PUBLIC WORKS DEPARTMENT TEQUESQUITE ARROYO TRUNK SEWER REPLACEMENT PHASE IIB

Project Completion As-Builts

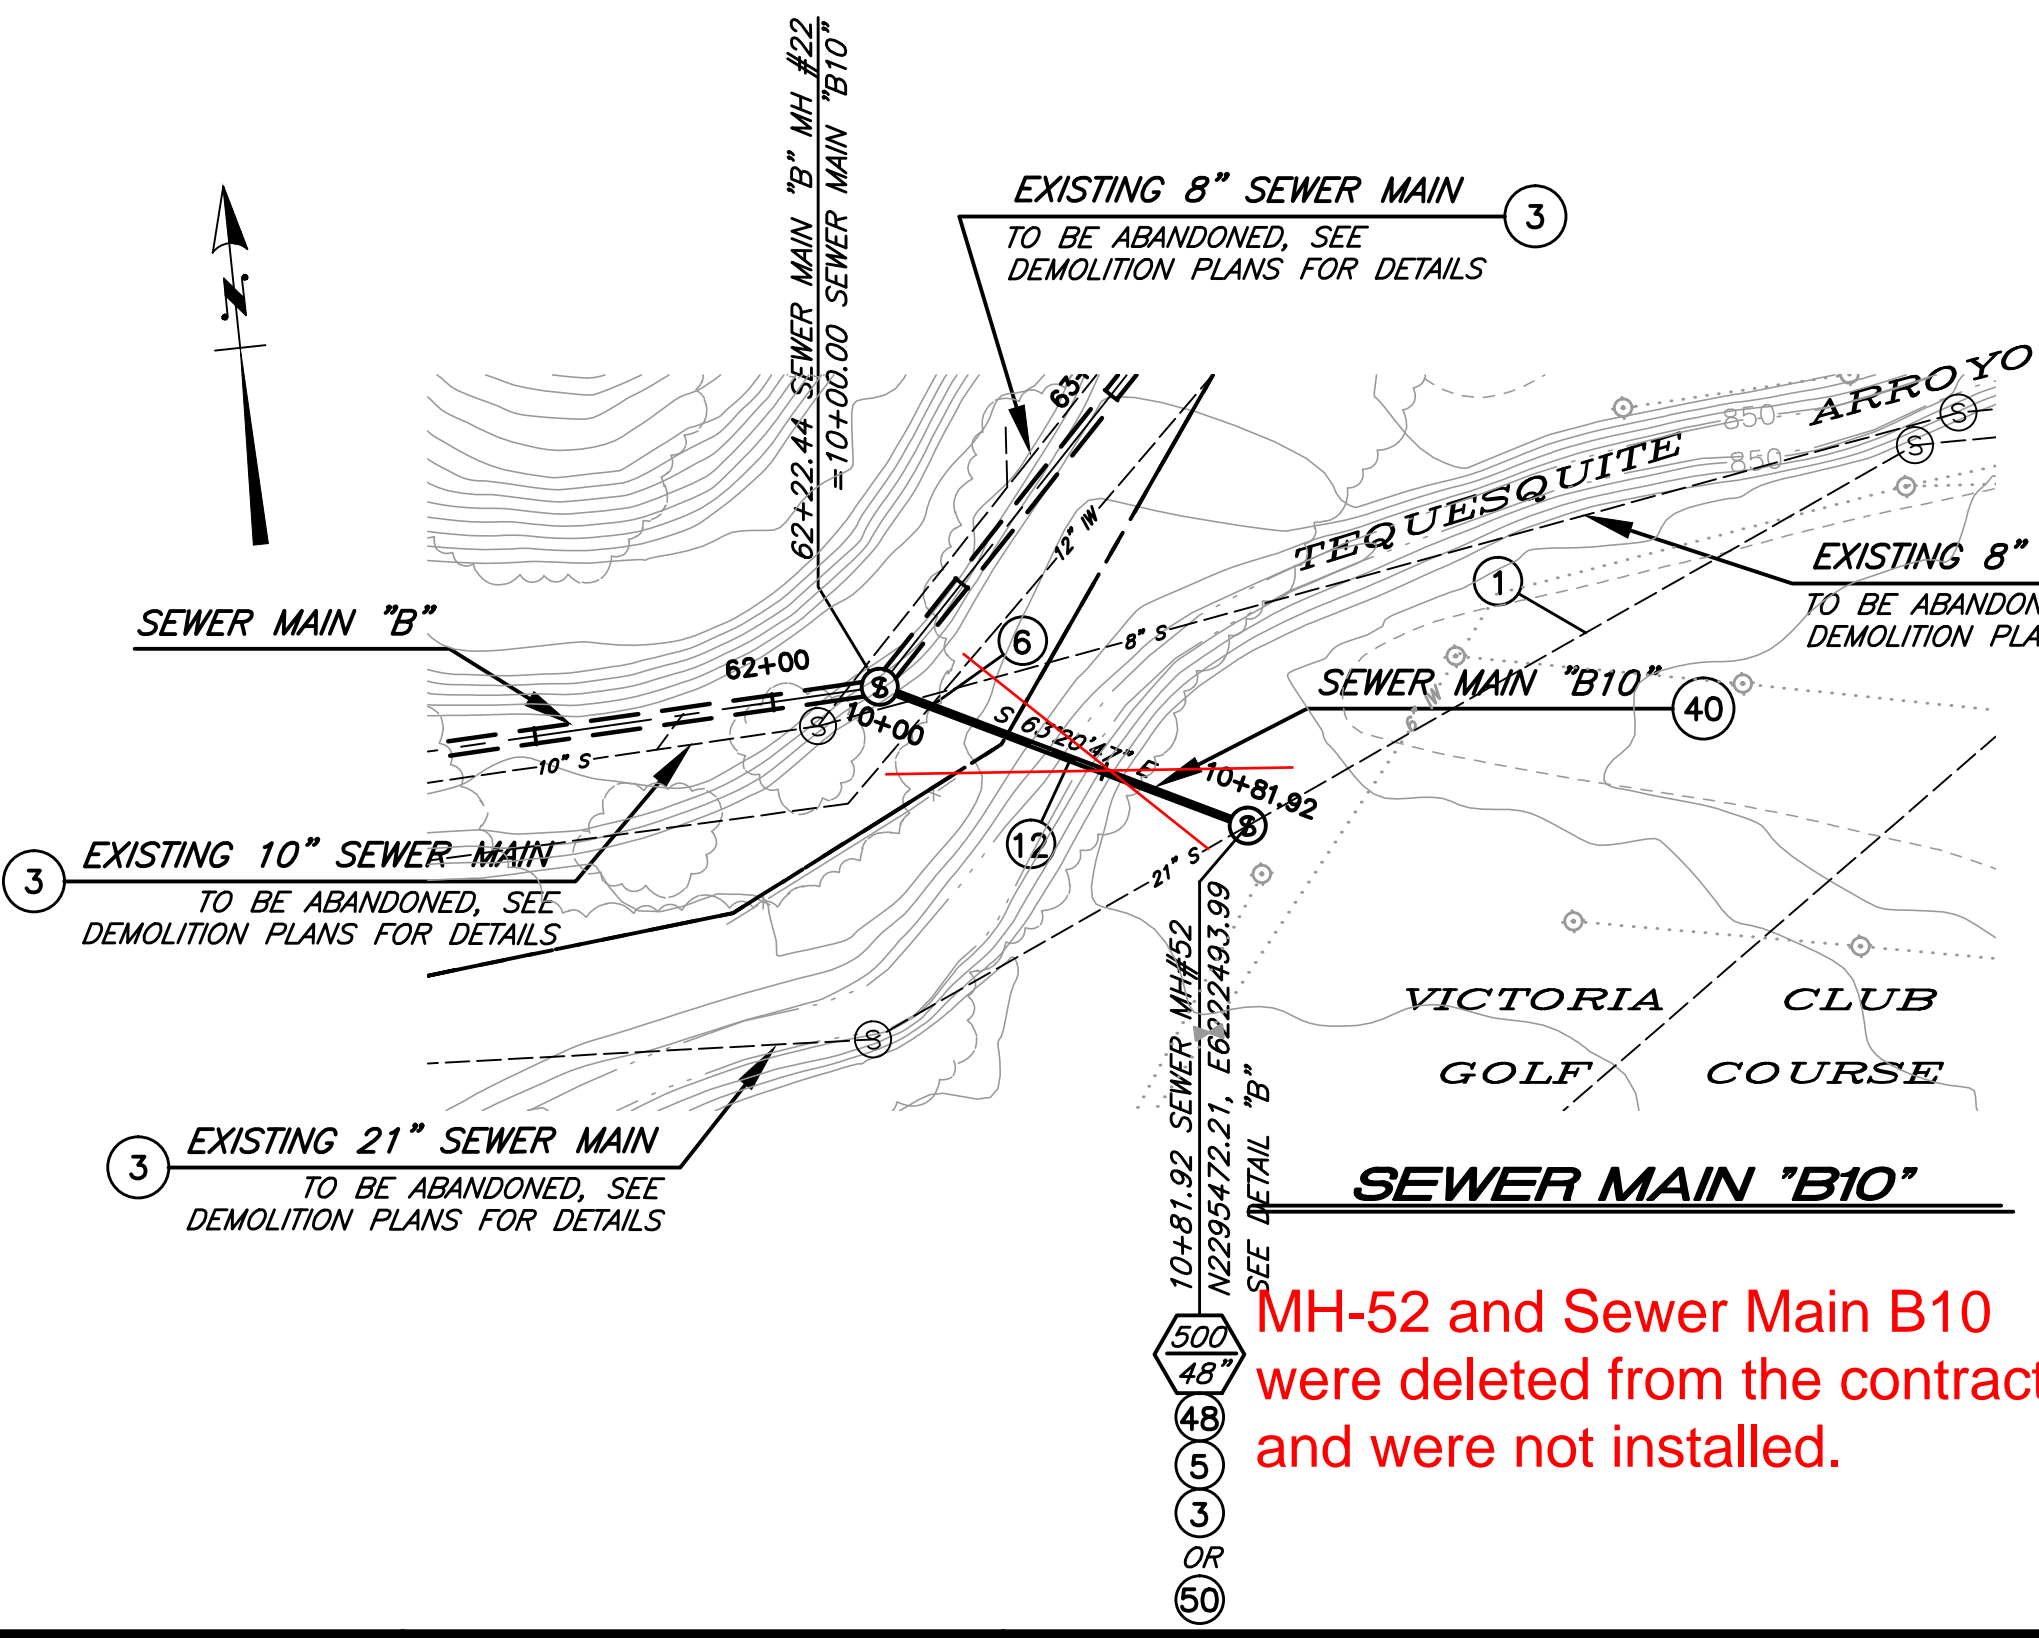
MH-52 and Sewer Main B10 were deleted from the contract and were not installed.

JUNCTION BOX (SEWER MH #42) CONSTRUCTION PLAN
NTS

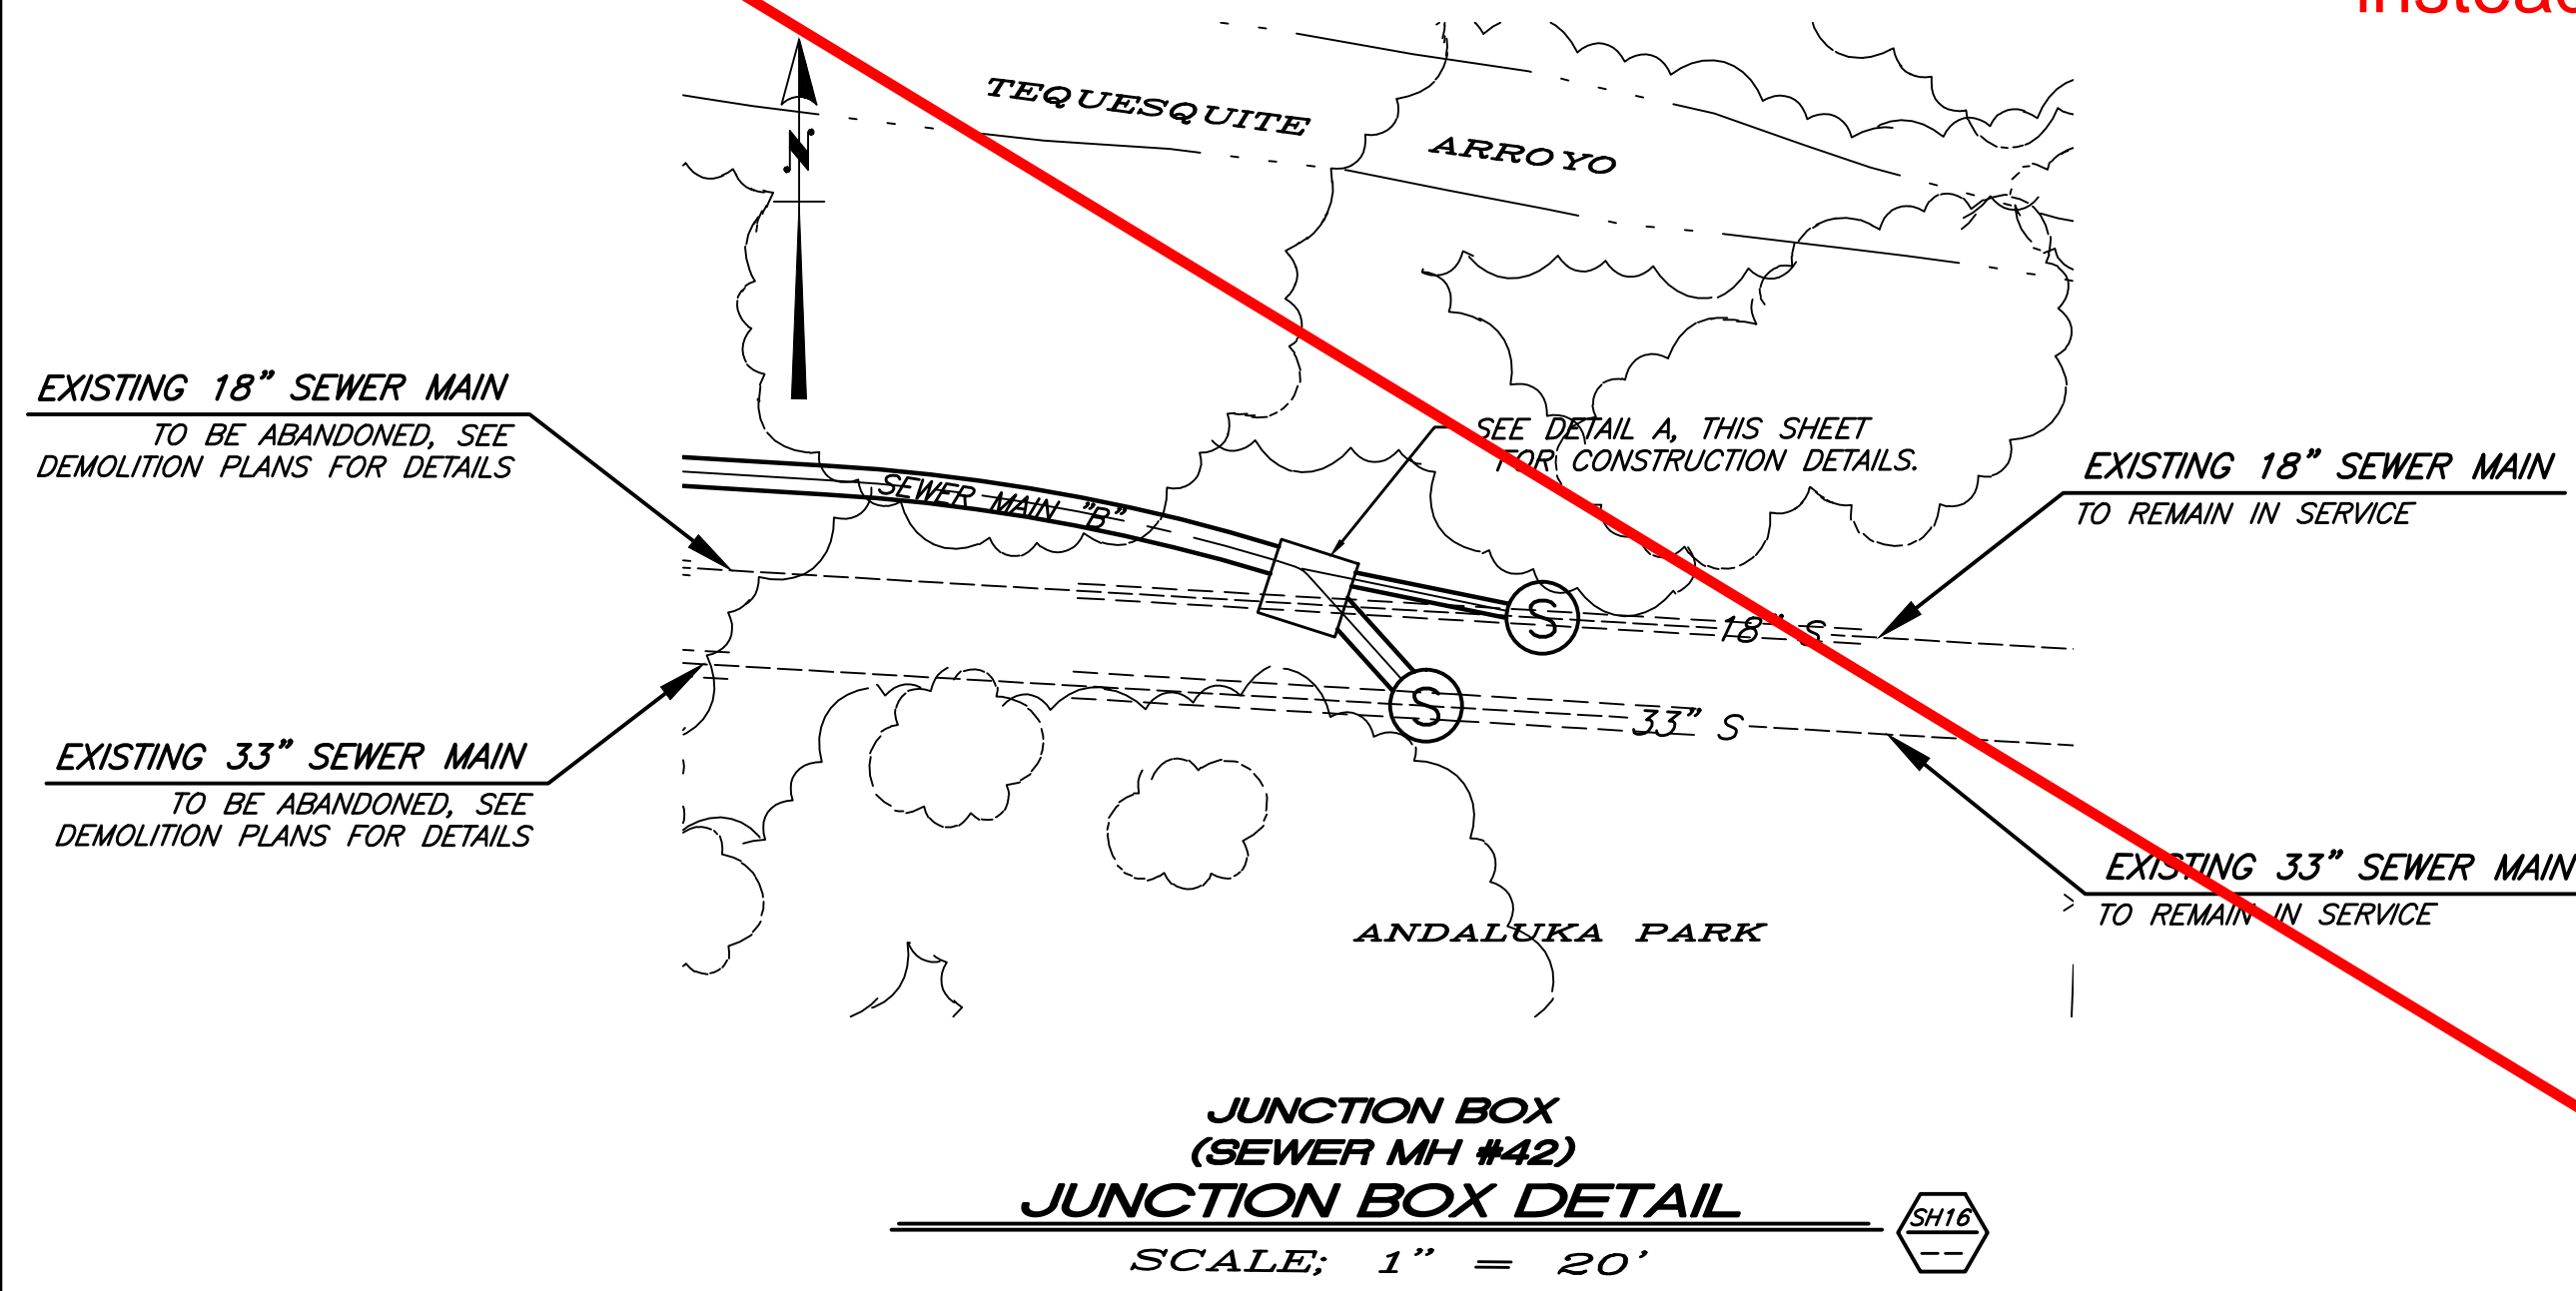
A Manhole was installed instead of a Junction Box

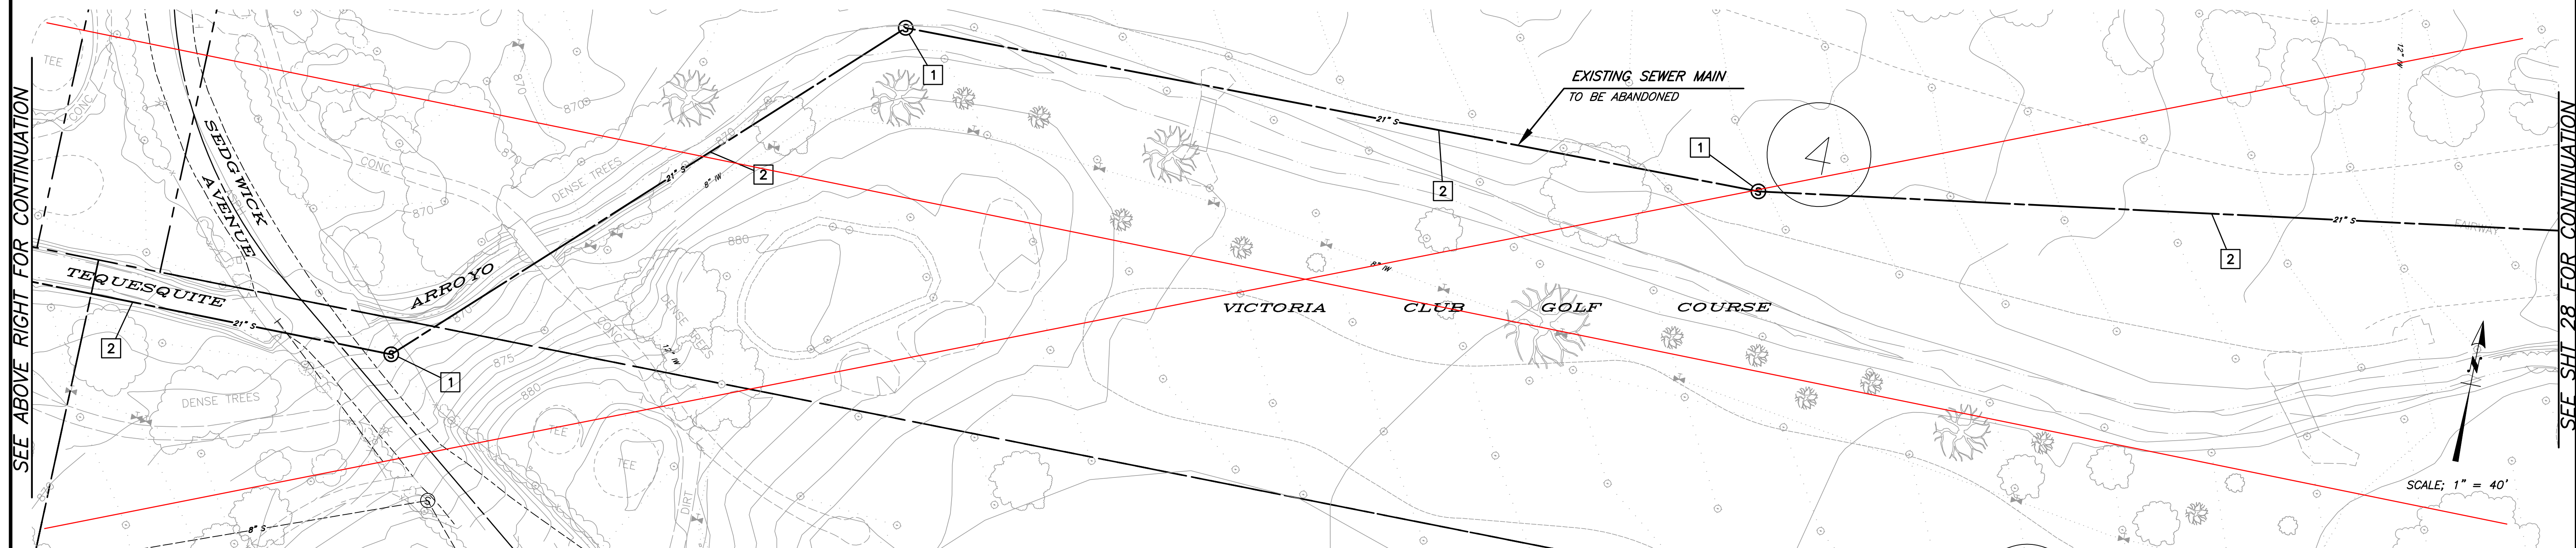
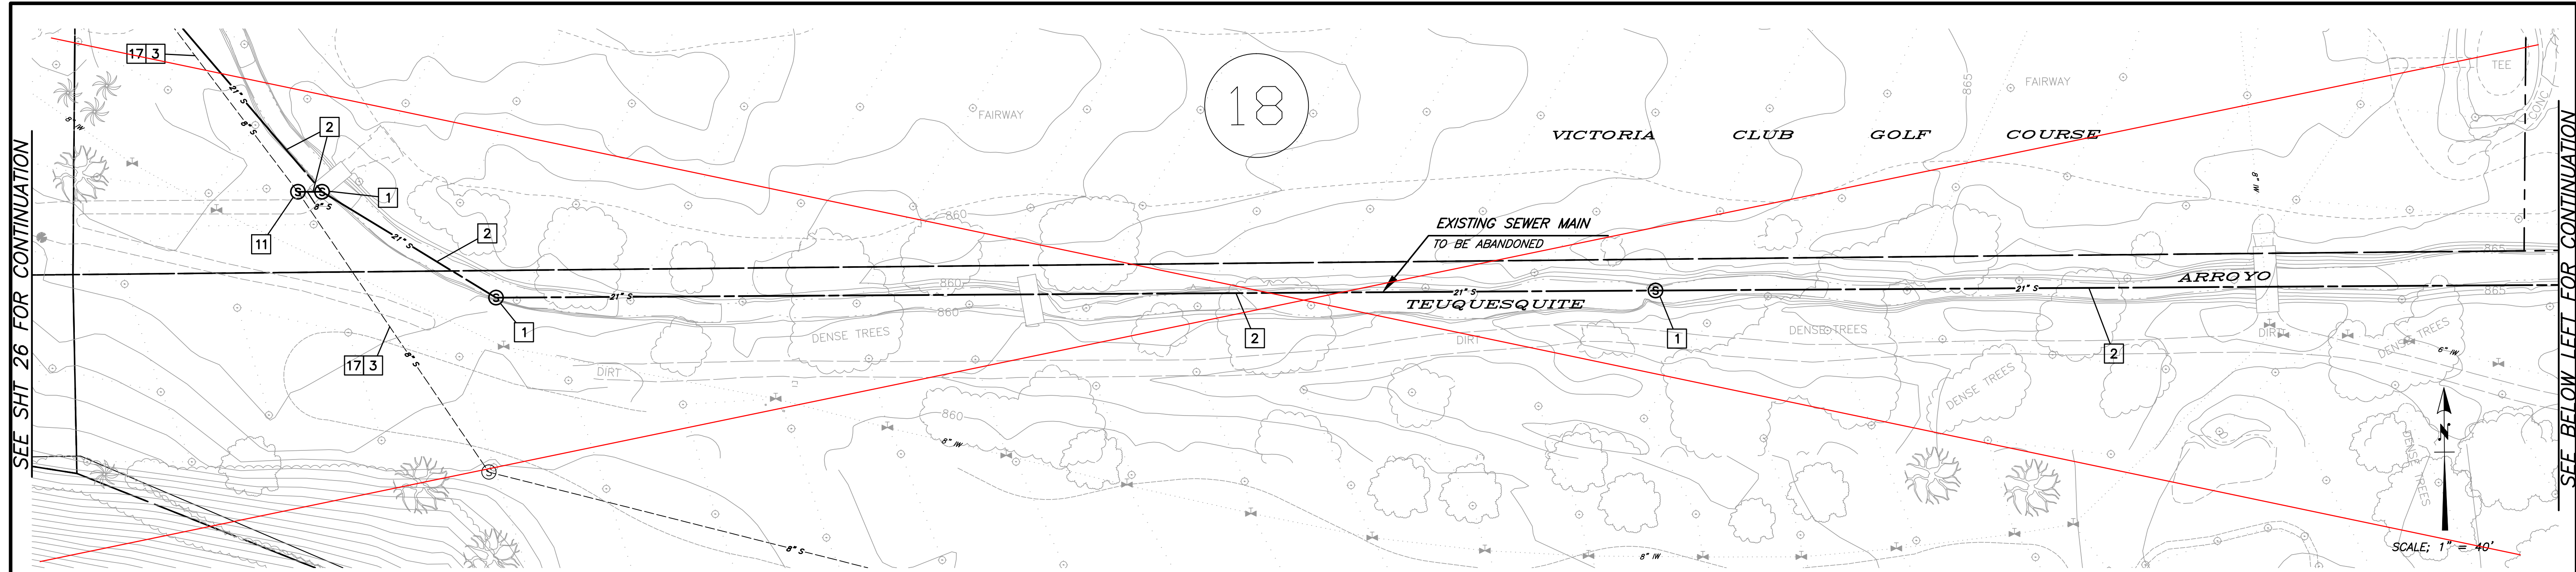
Only the lines in red were abandoned. The remaining line was left in service.
